# ASCENT CHURCH

### GRADING & EROSION CONTROL PLAN

PCD File PPR265

**POND OUTLET STRUCTURE PROFILE**  
SCALE: 3/4"=1'

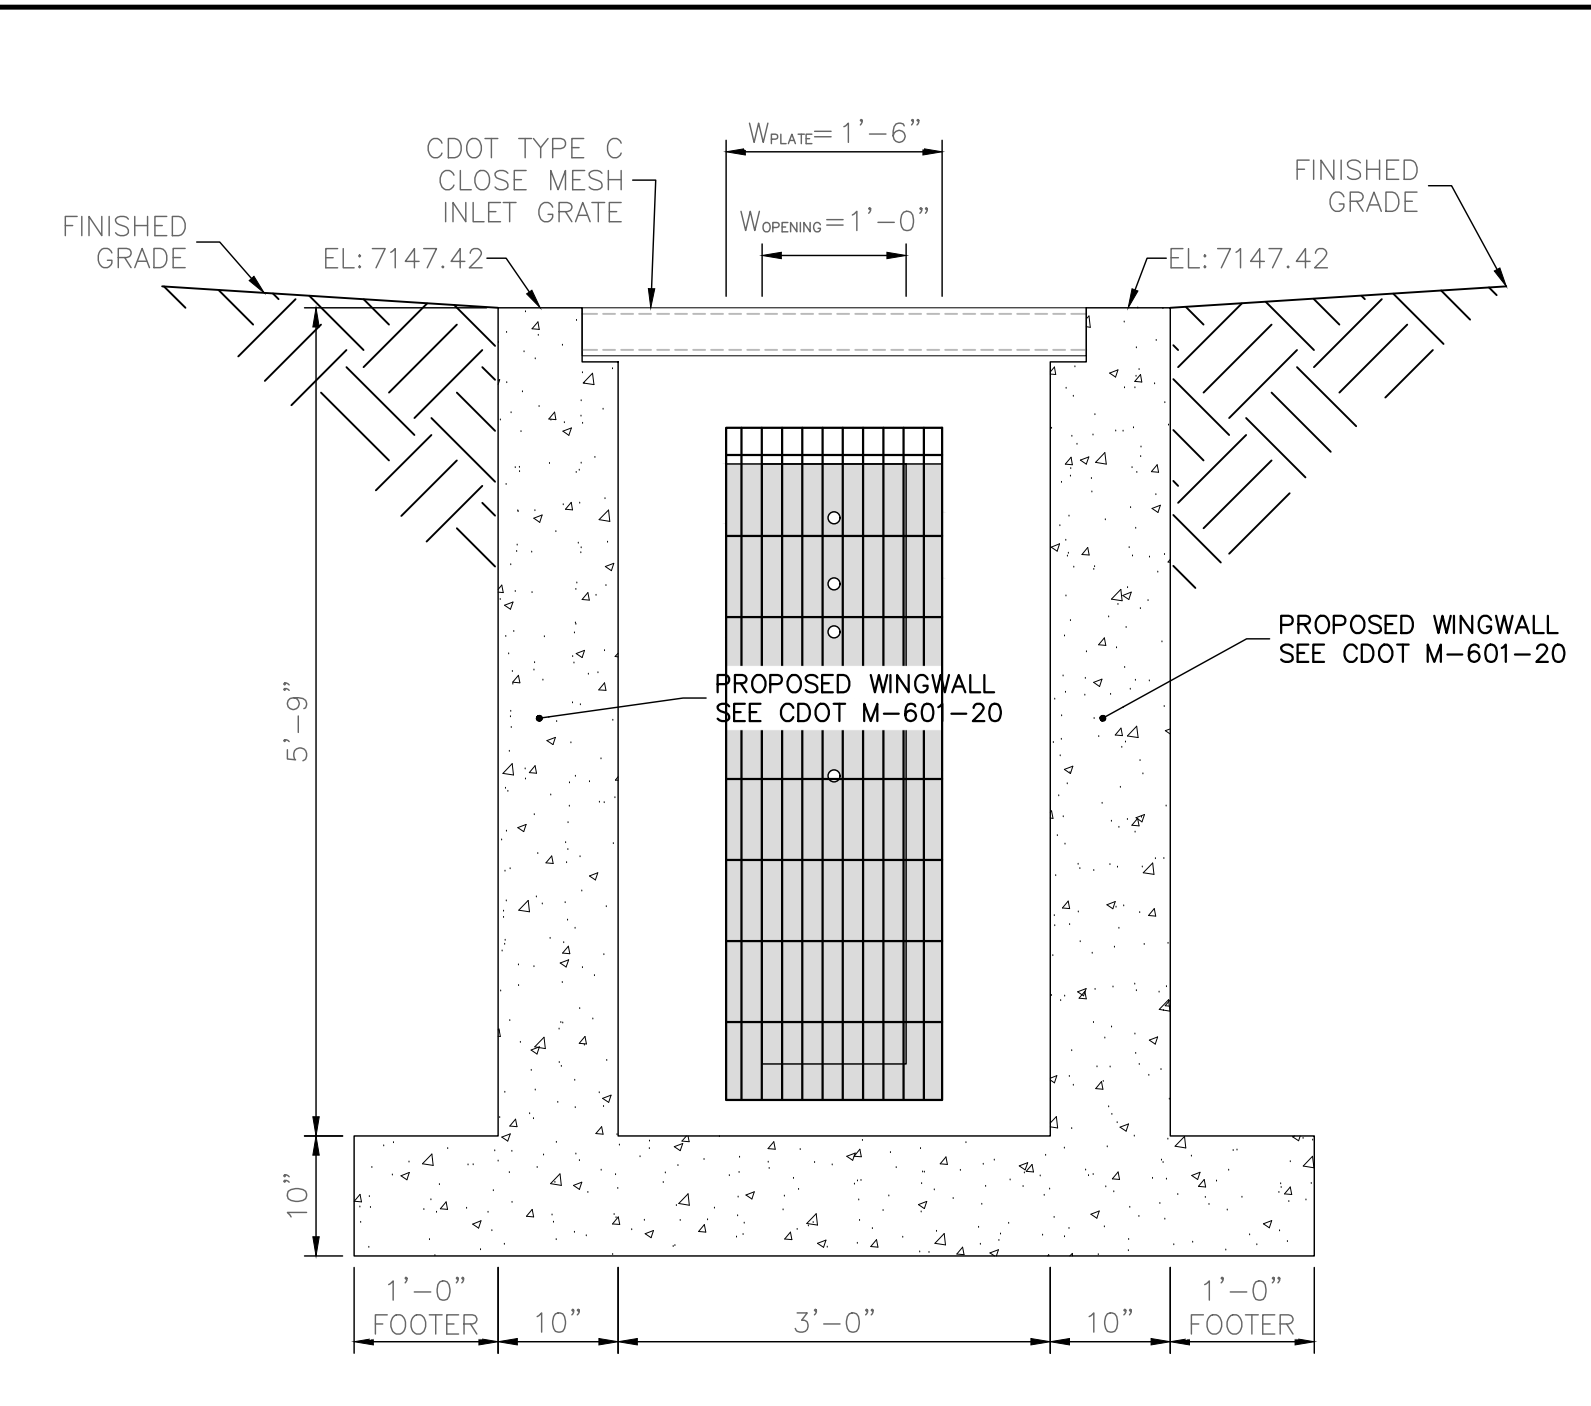
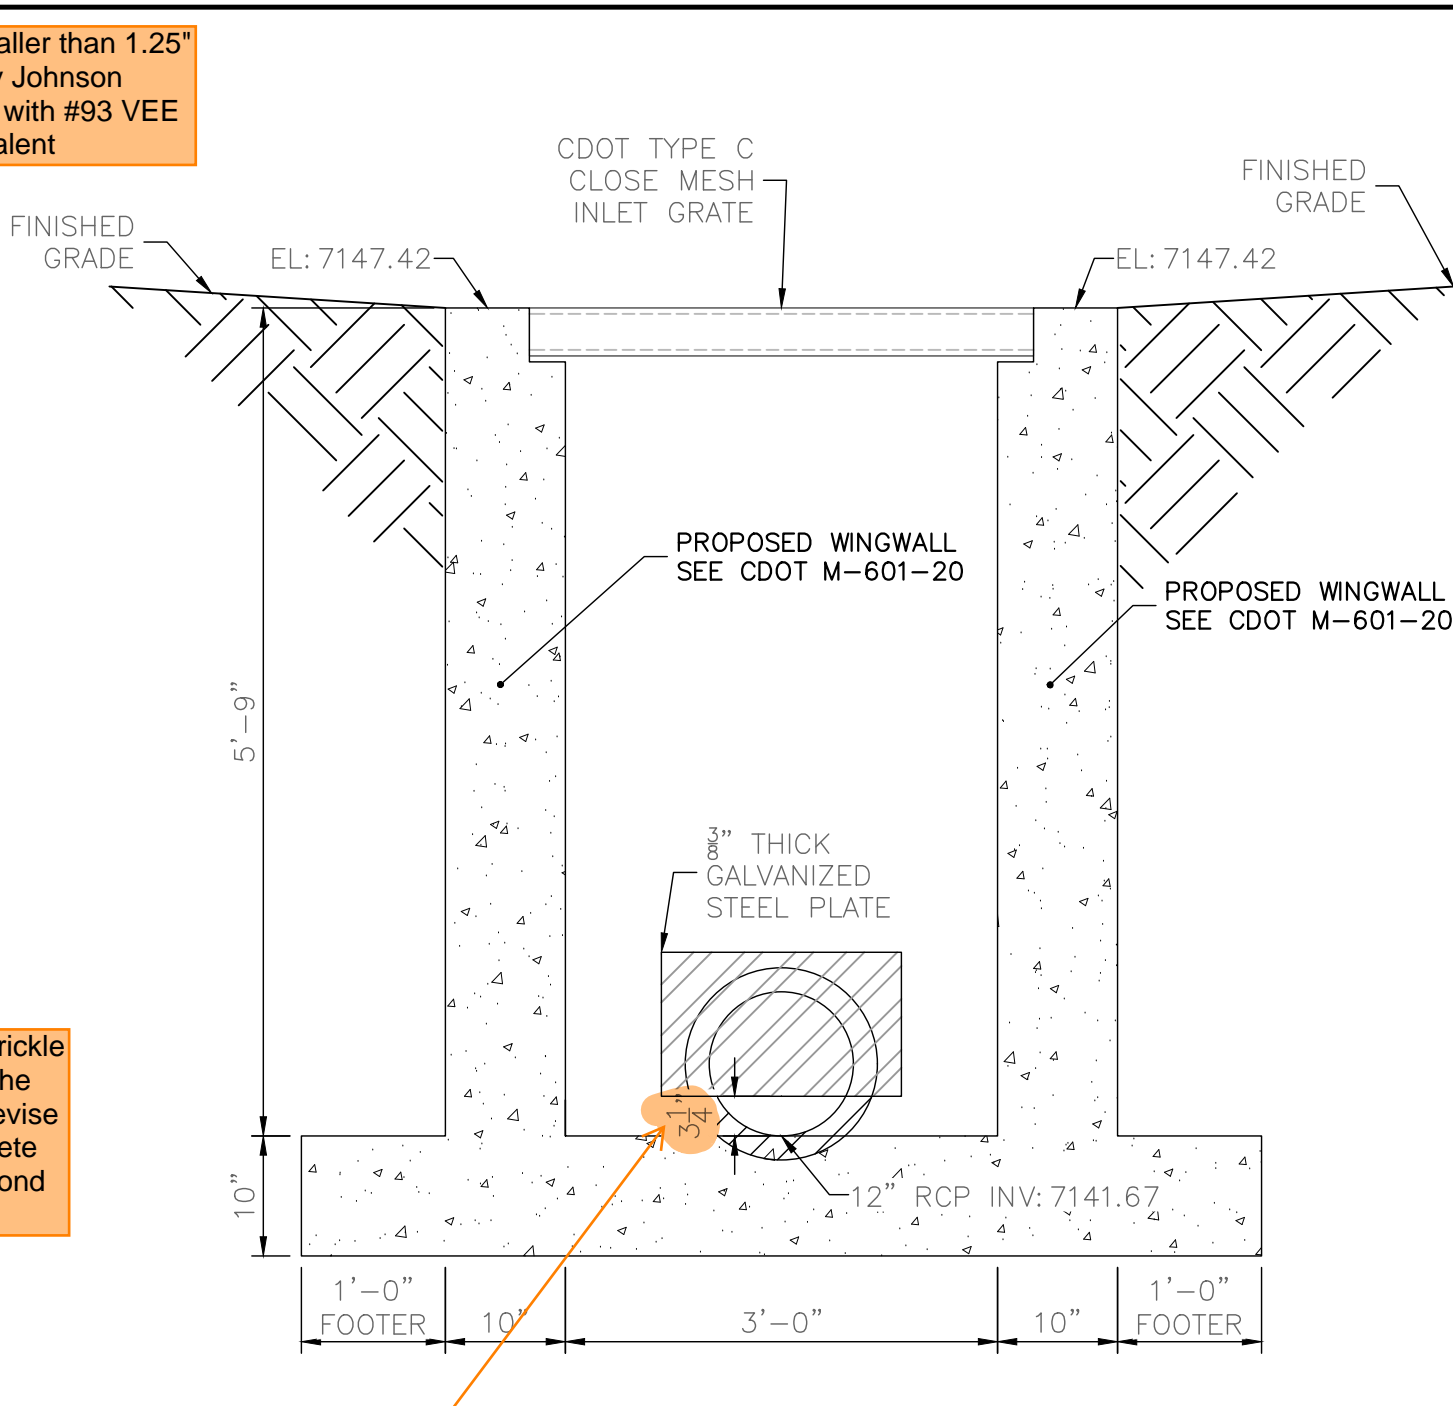
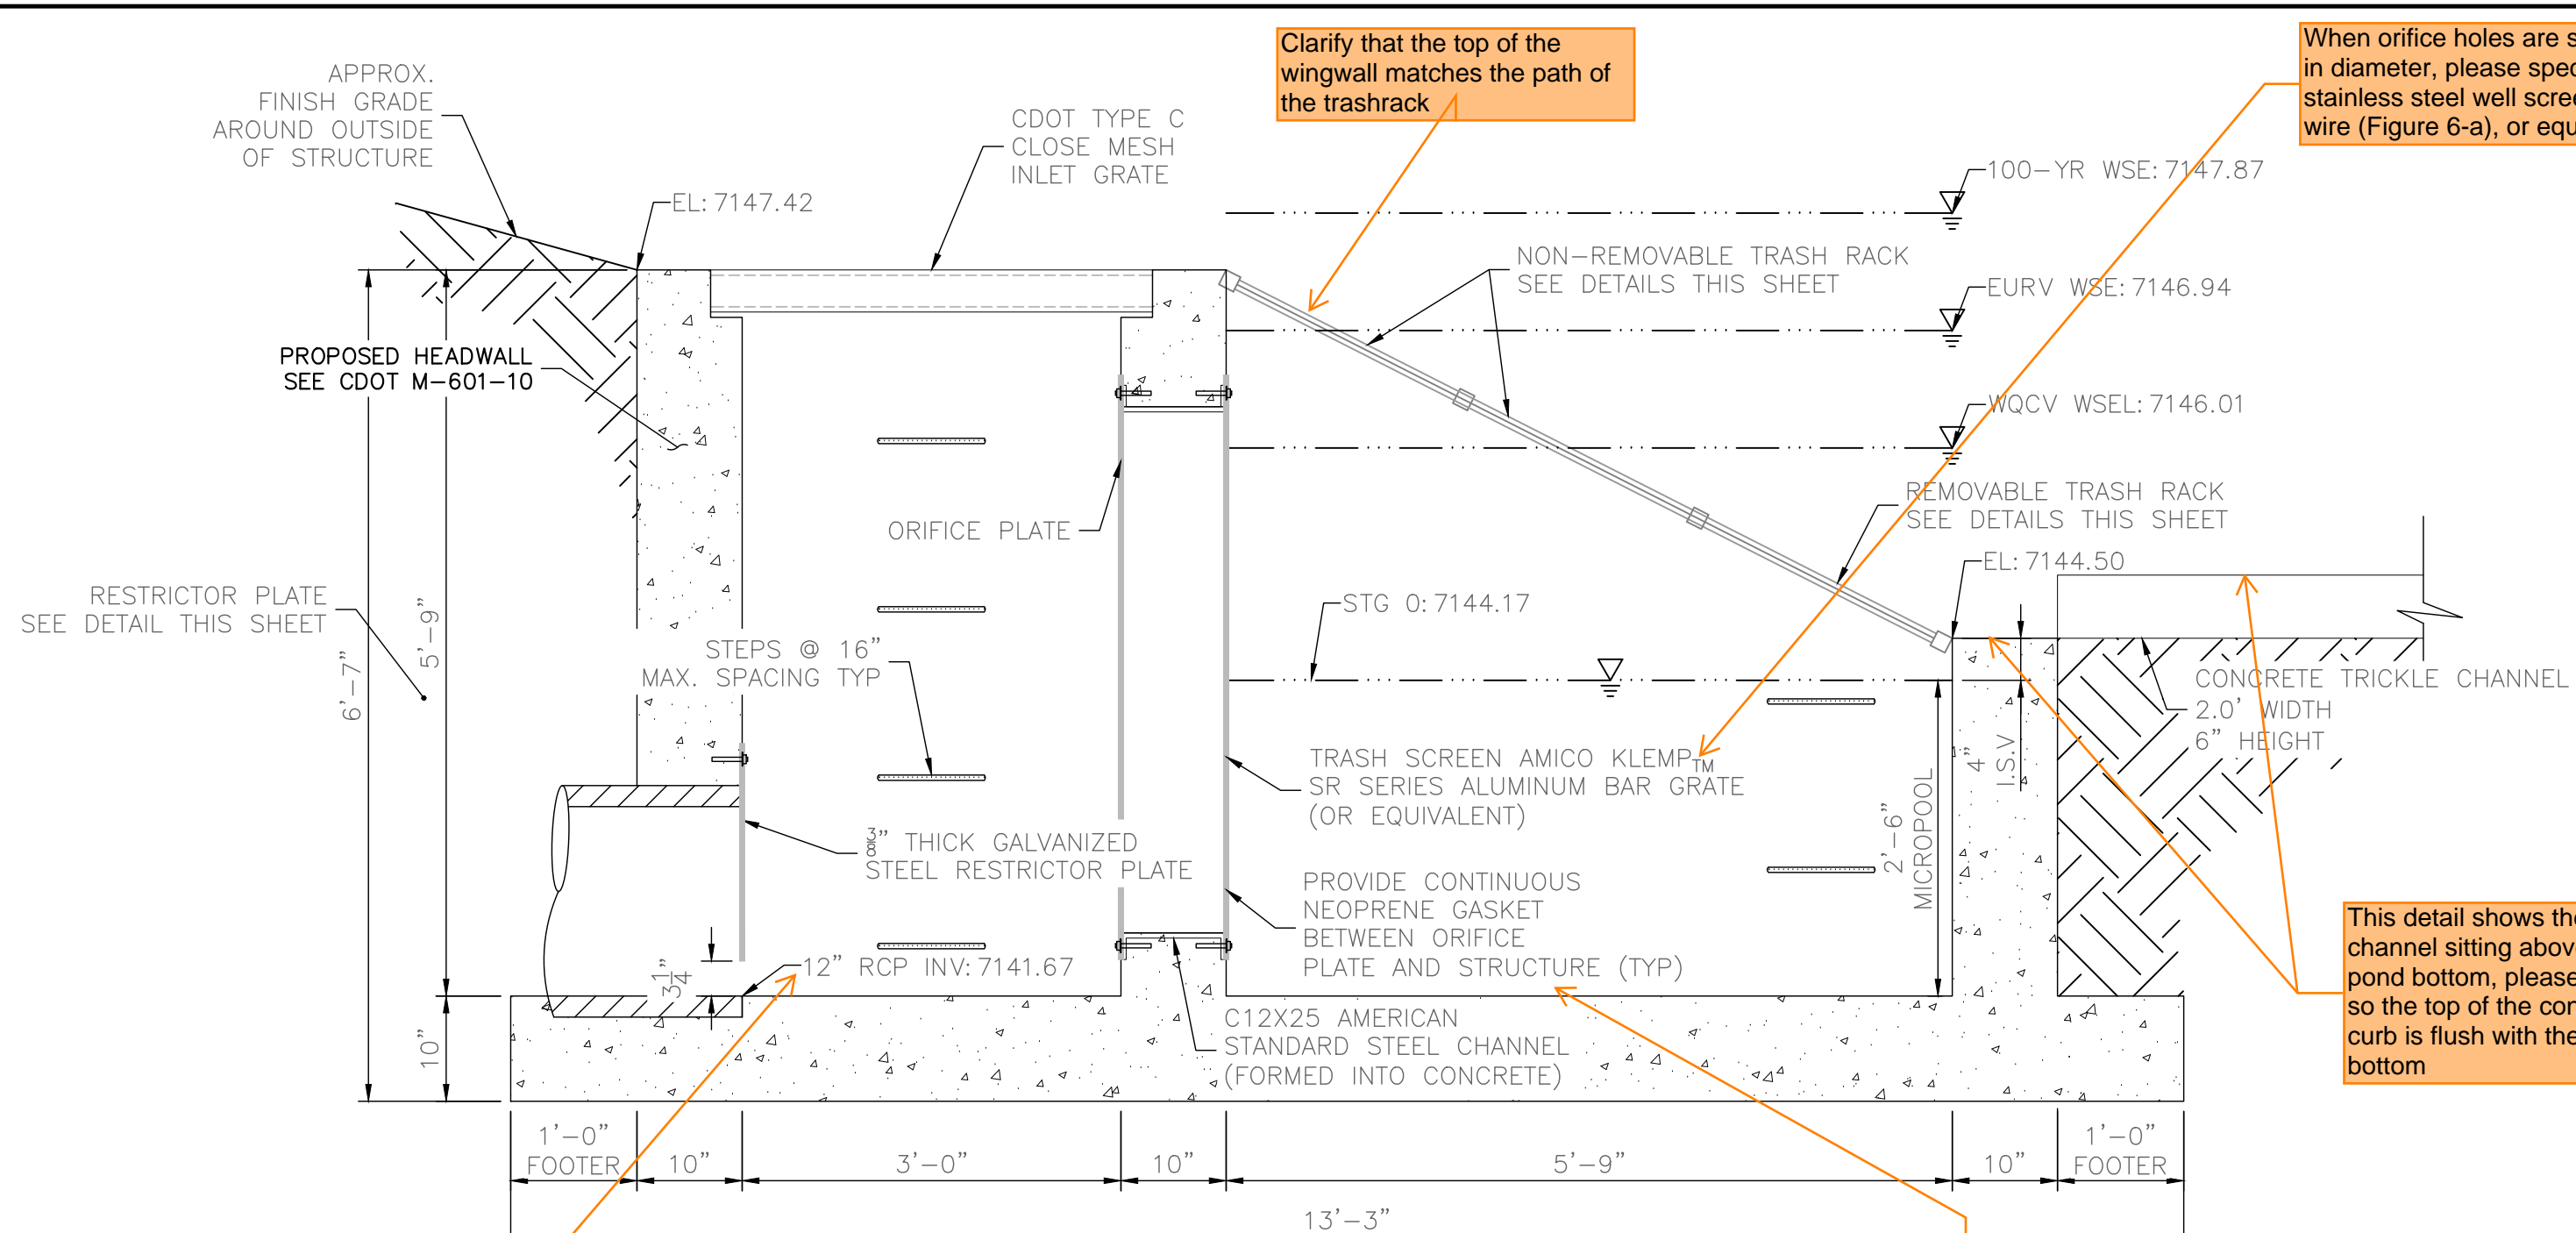
Per DCMv1 Section 4.3 (UD Figure 6-a) and DCMv2 Section 11.3.1 (1st paragraph), outlet pipe should be 18" minimum.

Provide more detailed gasket info like thickness, width, brand/model, etc.  
Based on input gathered from industry experts, below is the recommended gasket spec:  
The gasket shall be made of 1/4-inch thick, 60 durometer EPDM rubber in a continuous sheet the size of the orifice plate. The sheet shall be placed between the orifice plate and the concrete wall, with the width of the overlap between the plate and the concrete. Openings shall be cut into the sheet corresponding to the plate bolt holes and the concrete wall opening, cuts made either by the contractor in the field or by the manufacturer. Or equivalent gasket approved by EPC. Note that caulk is not an approved equivalent and will not be accepted by EPC.

Dimension does not match "height above pipe invert" in design spreadsheet

This detail shows the trickle channel sitting above the pond bottom, please revise so the top of the concrete curb is flush with the pond bottom

When orifice holes are smaller than 1.25" in diameter, please specify Johnson stainless steel well screen with #93 VEE wire (Figure 6-a), or equivalent

Clarify that the top of the wingwall matches the path of the trashrack

**ORIFICE PLATE DETAIL**  
SCALE: 3/4"=1'

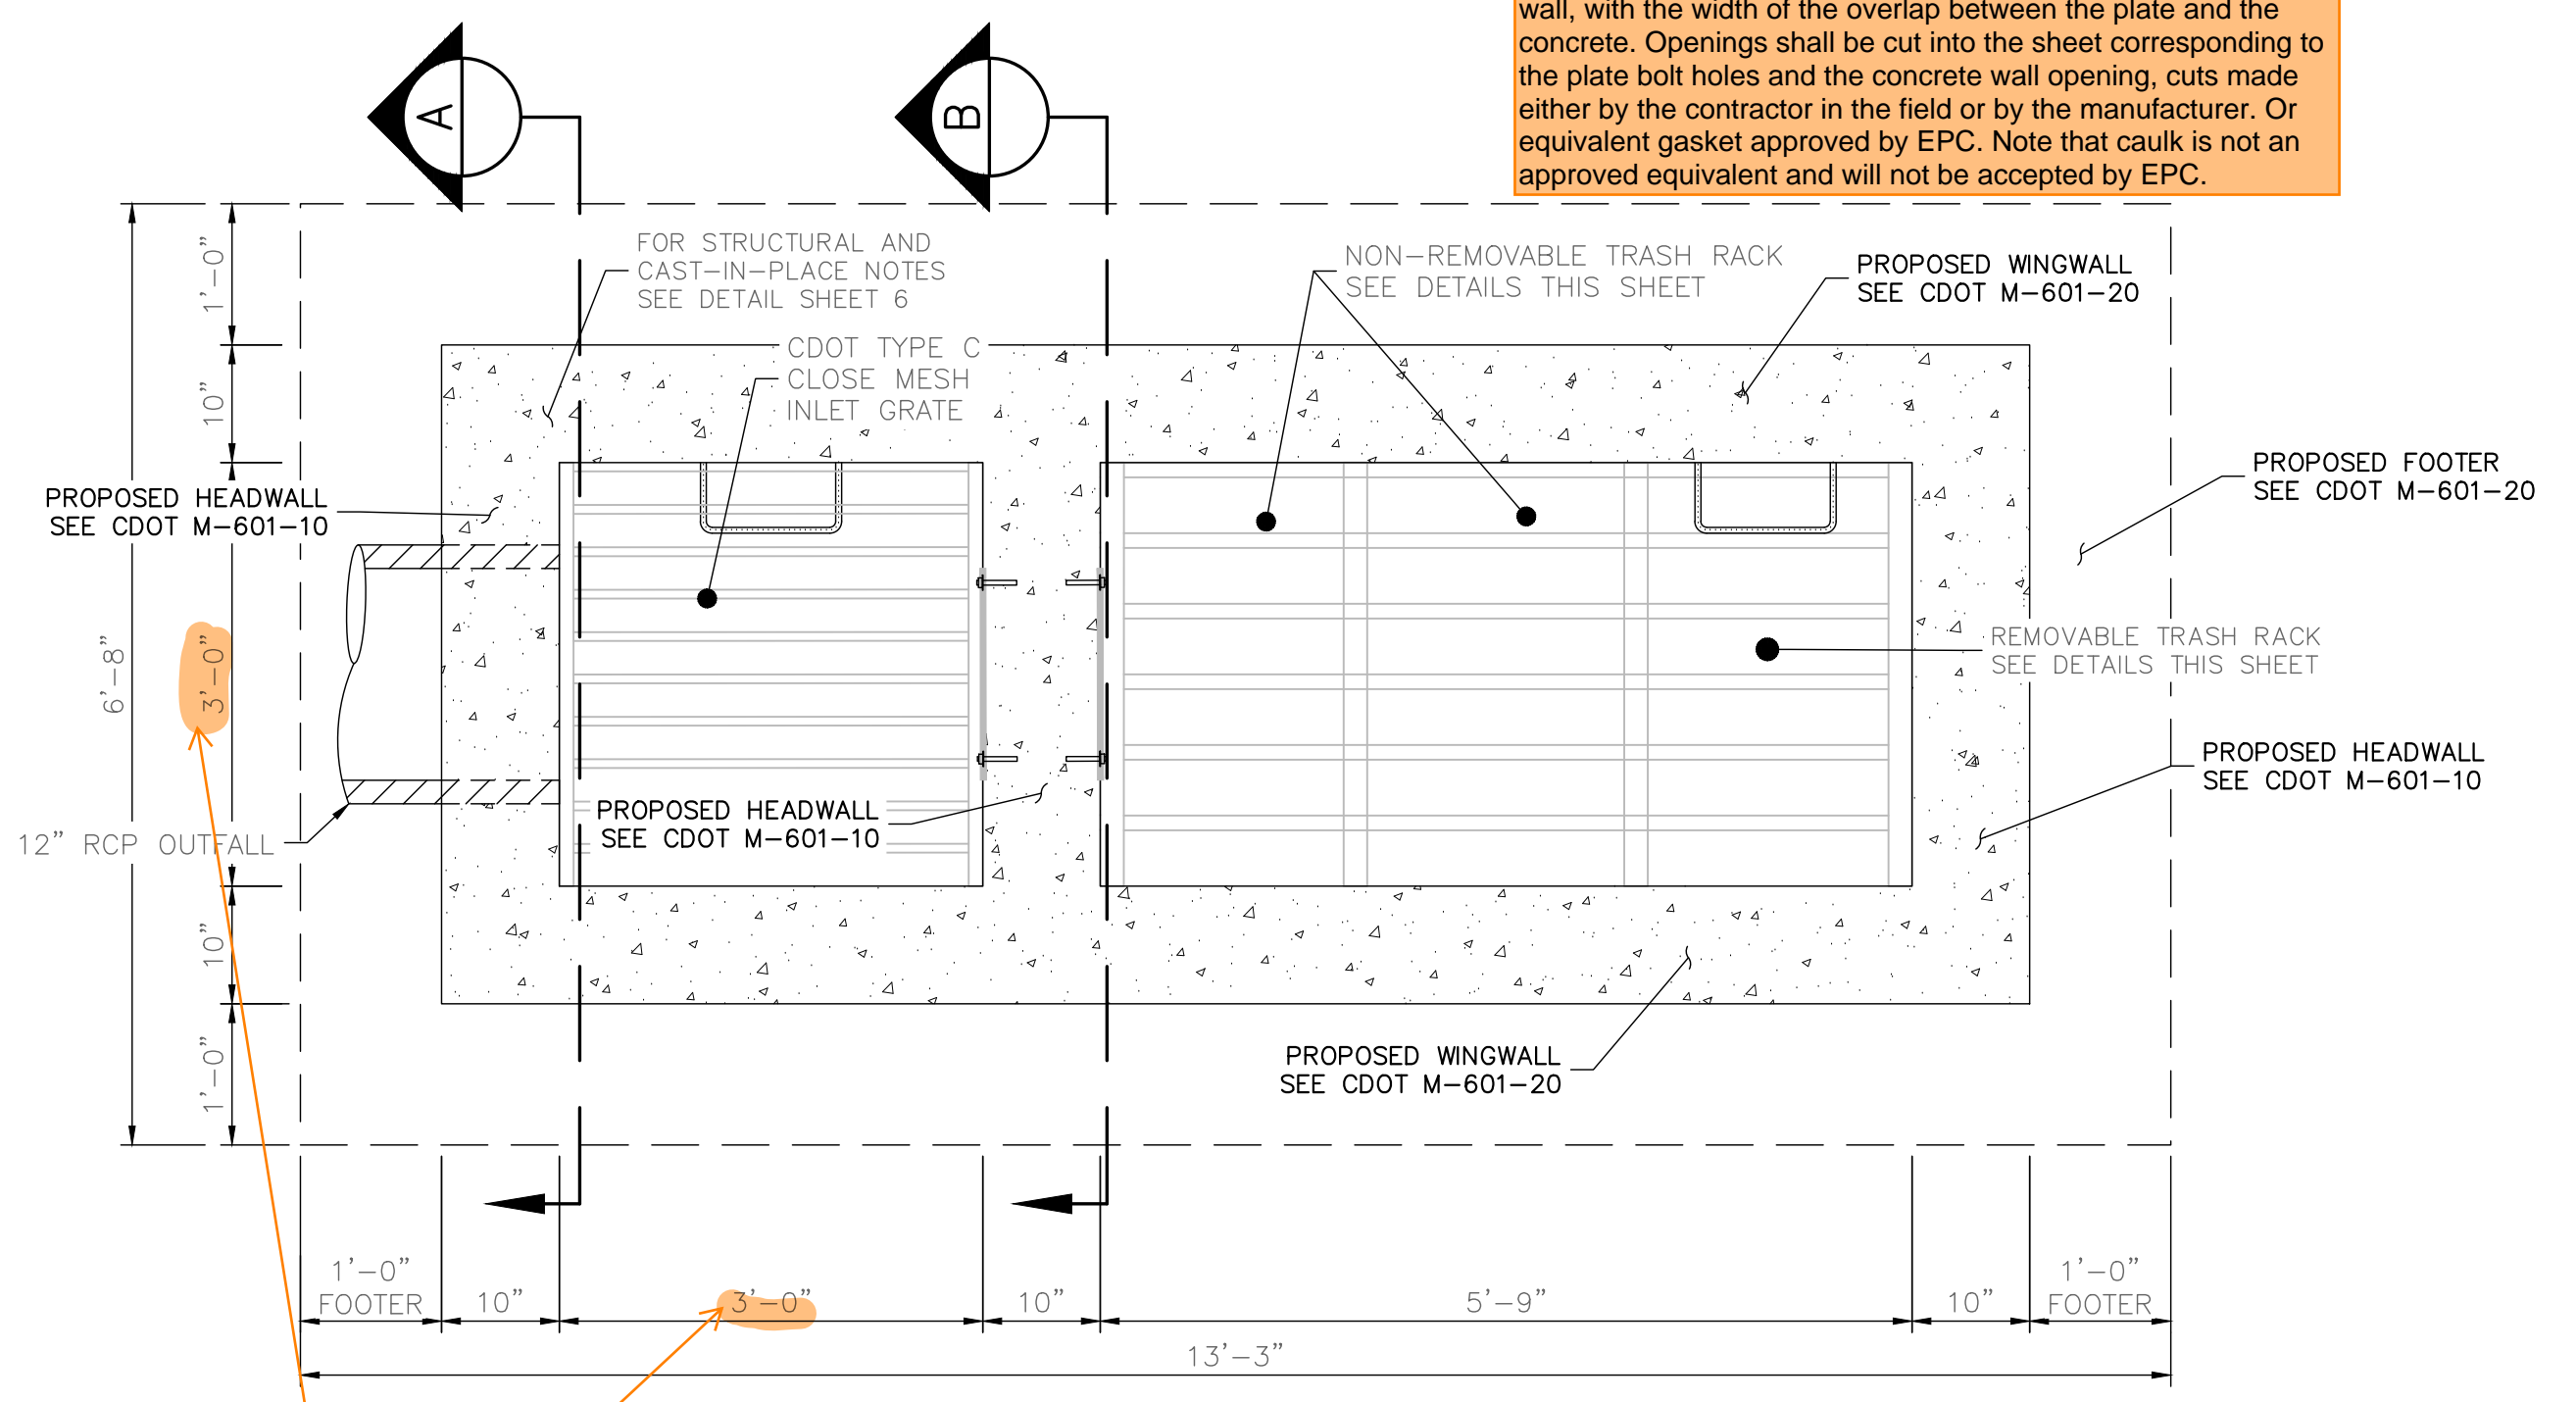
Does not match design spreadsheet
